AGENDA
PLANNING AND ZONING COMMISSION MEETING
CITY OF CREVE COEUR, MISSOURI
MONDAY, JUNE 21, 2021

1. Application #21-020: Minor Site Plan for an Eight-Foot-Tall Sight-Proof Wood Fence Within the Front-Yard Setback Along I-270 for the Property Addressed as 23 Sackston Woods Lane

2. Application #21-021: Re-Approval of a Site Development Plan for a 20 Unit Apartment Building at 10809-10819 Olive Boulevard

APPLICATION TO PLANNING AND ZONING COMMISSION
#21-020: MINOR SITE PLAN FOR AN EIGHT-FOOT-TALL SIGHT-PROOF WOOD FENCE WITHIN THE FRONT-YARD SETBACK ALONG I-270 FOR THE PROPERTY ADDRESSED AS 23 SACKSTON WOODS LANE

Figure 1: Applicant's Site Plan.

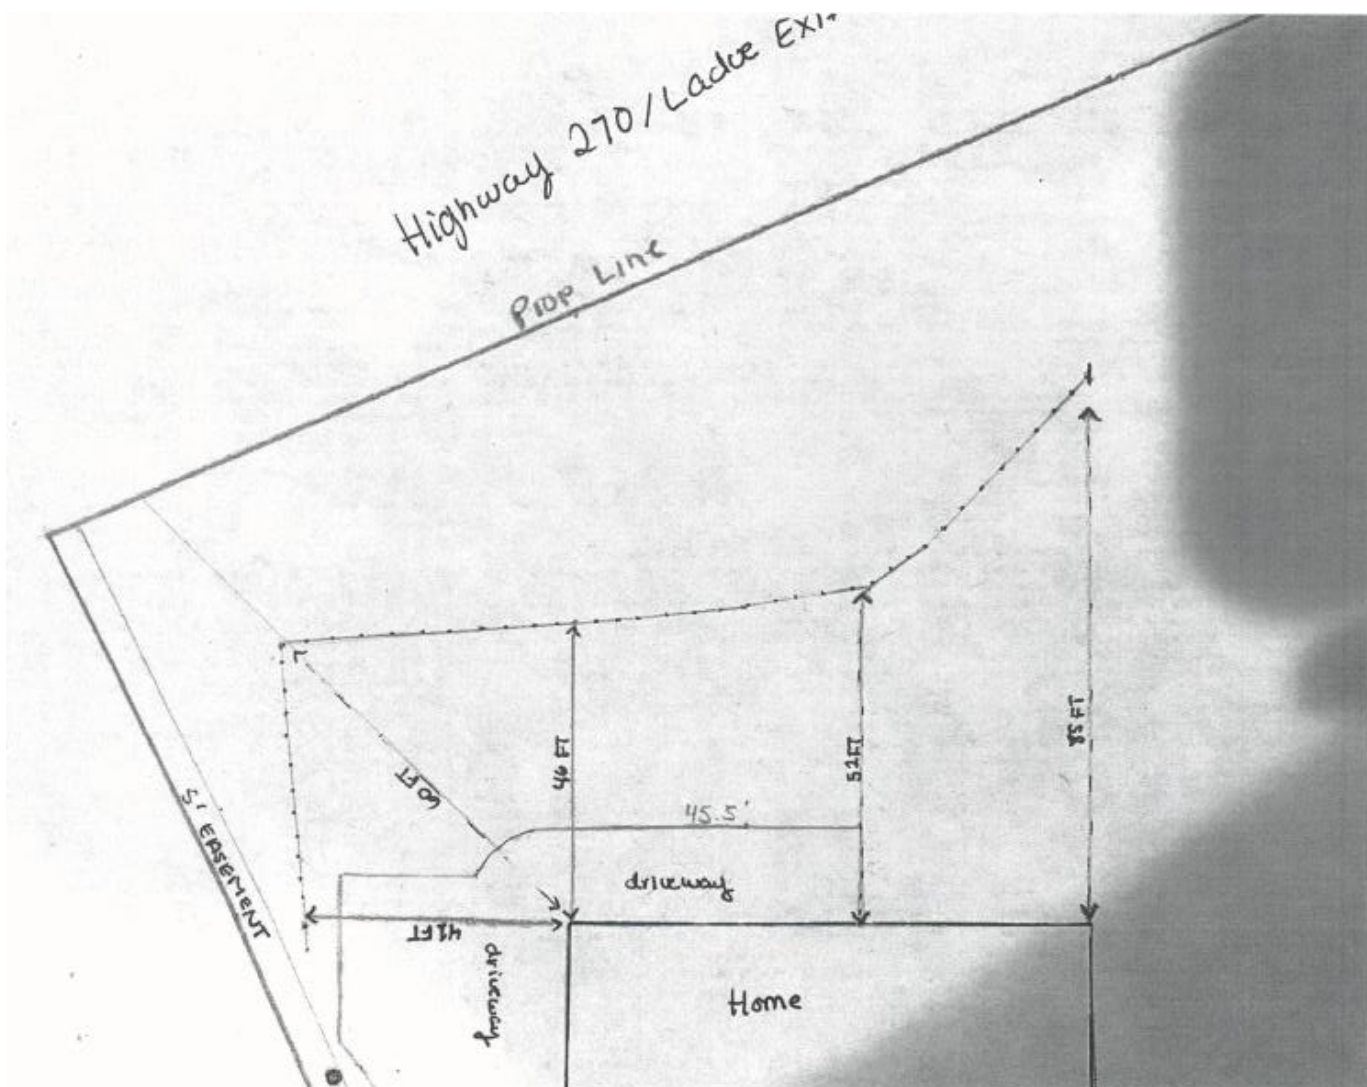
The Site Plan also shows a 5-foot chain link fence at the property line, that would presumably be installed by MoDOT as a safety barrier. Staff has viewed the surrounding area and the proposed/installed fence appears to be the only 8-foot-tall wood fence in the vicinity. The existing vegetation does provide screening of the structure between it and I-270, particularly in the warmer months. Staff suggests that if the Commission determine that a sight-proof fence is appropriate at this location, that specific discussion on the height be reviewed to determine whether adjacency to the interstate highway represents a unique screening problem to allow the fence to be taller than 6-feet. Staff recommends that any approval should require additional wood be added to hide the support bracing from view along I-270 as required by the design standards of the fence code.

If the members of the Planning Commission find the applicant's reasons for the fence location, height and design sufficient, they can approve it as proposed or with the conditions recommended by staff. If the request is denied, the Applicant may remove the existing fence and construct a new six-foot sight proof fence at the 50-foot setback line, or have a 4 foot, open-slatted, metal fence at 15 feet from the rear property line, with a new fence application permit.

Figure 6: Close-up of the site plan where greater pedestrian interest needs to be provided.

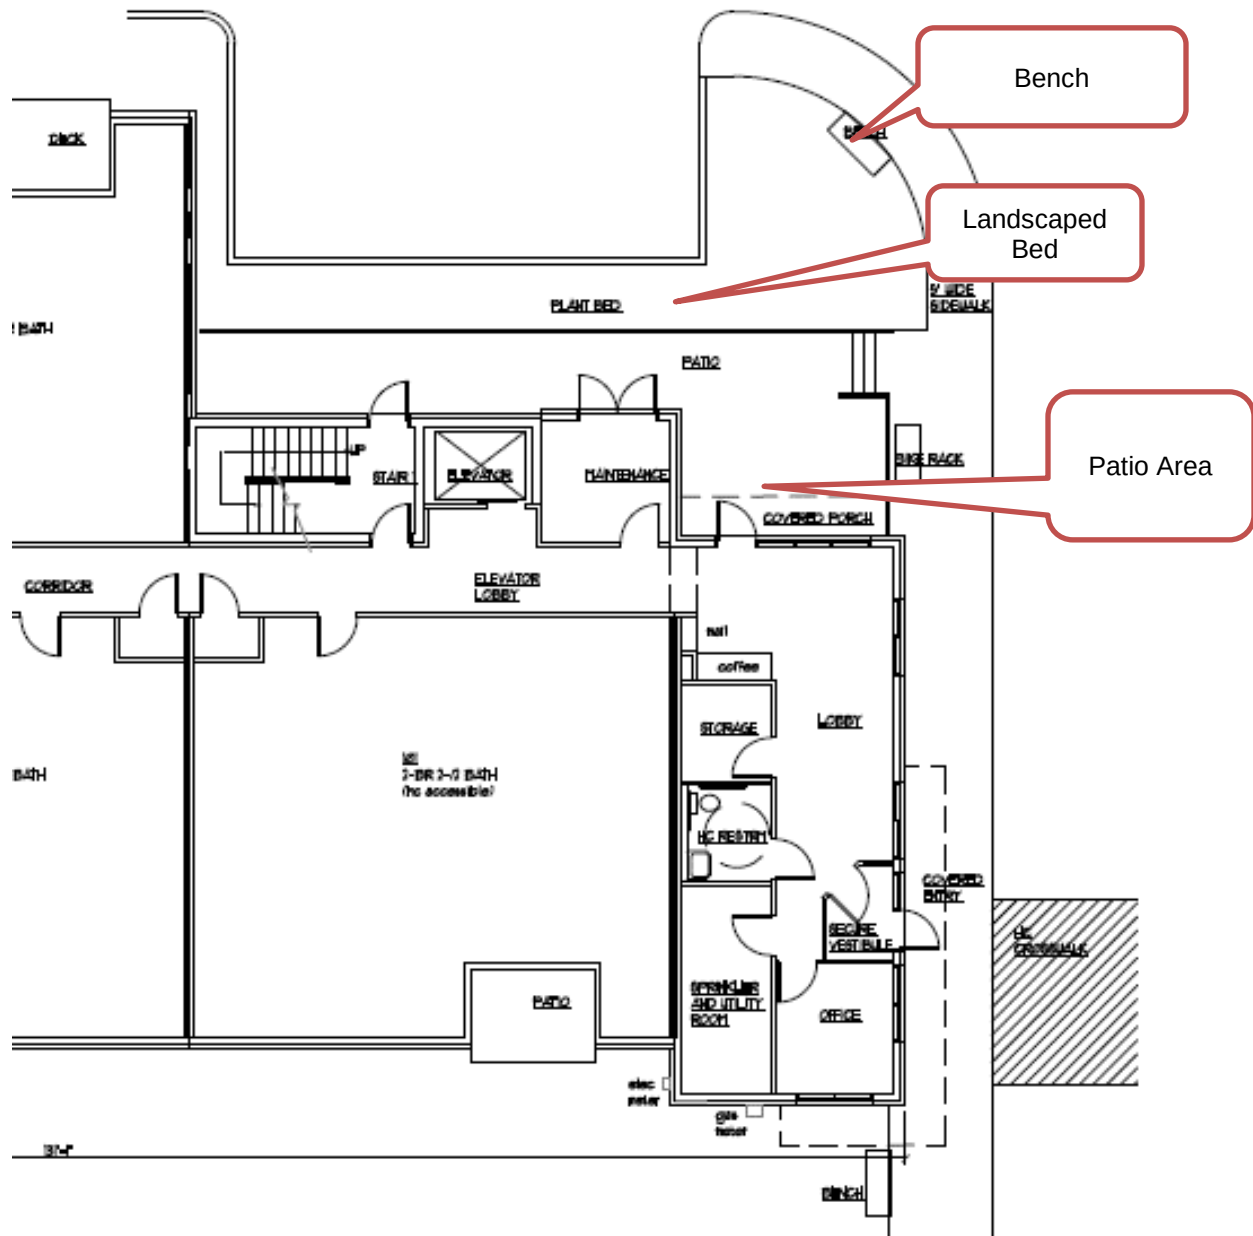
parking to the north elevation to the lobby/entrance need to provide better connections as opposed to just ending at the parking lot, and the placement of a single bench within the landscaping seems poorly placed. A better integrated outdoor amenity space in this area would elevate the overall design of the area.

Figure 9: Close-up of the site plan showing the sidewalks with the sidewalk depth circled.

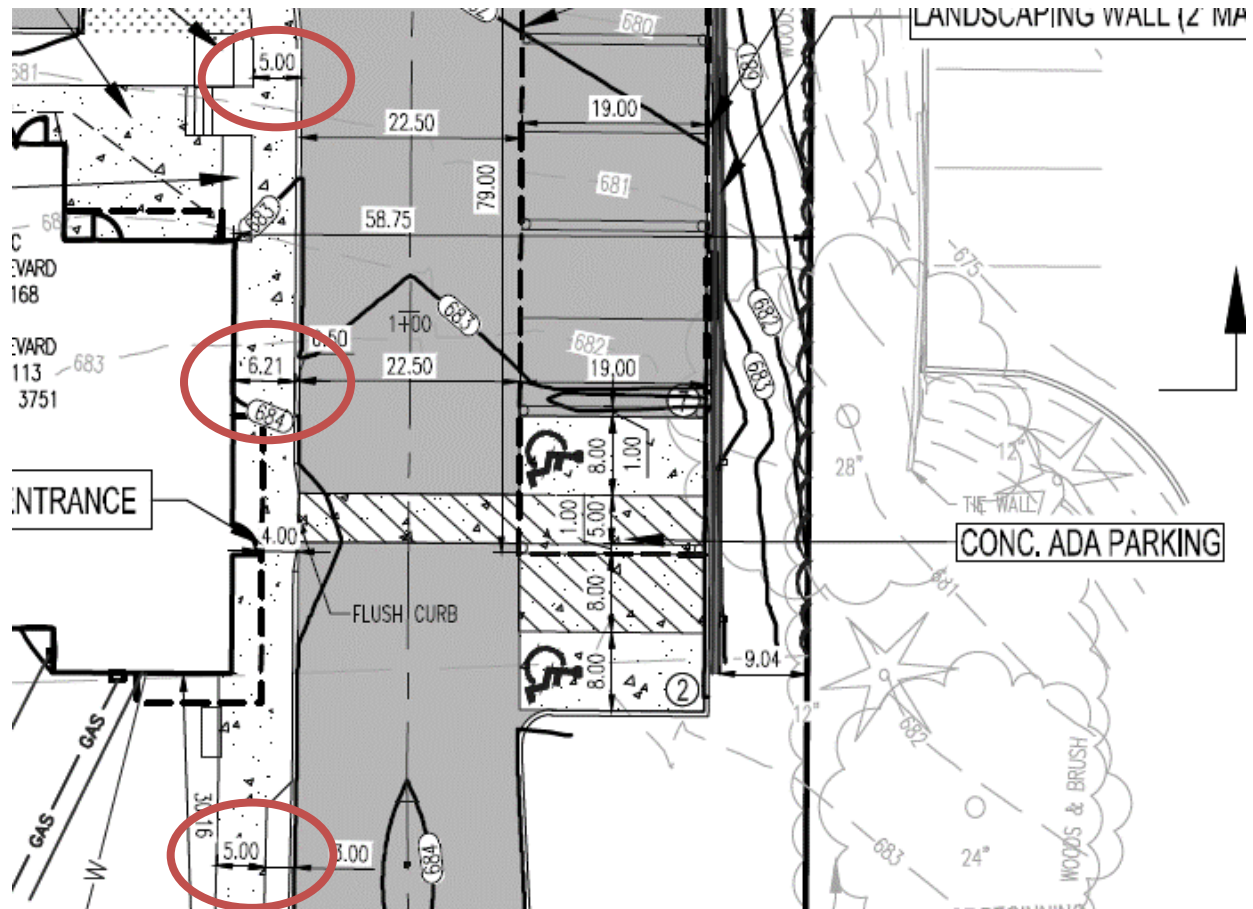
utilized where pedestrian circulation paths cross a vehicular route as determined by the Planning and Zoning Commission.
